Product Change Notification / SYST-27OHRV327

Document Change

ERRATA - PIC18(L)F24/25K42 Silicon Errata and Data Sheet Clarification

PIC18(L)F24/25K42 Silicon Errata and Data Sheet Clarification

Figure 44-5 Clock Timing

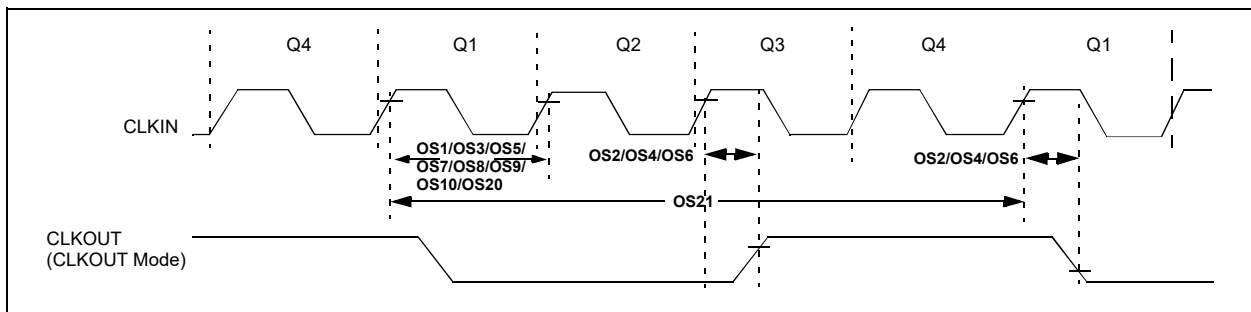
Figure 44-5 incorrectly shows the location of parameters OS1, OS2, OS3, OS4, OS5, OS6, OS7, OS8, OS9, OS10, OS20 and OS21. The correct location for the above-mentioned parameters is depicted in the following figure.
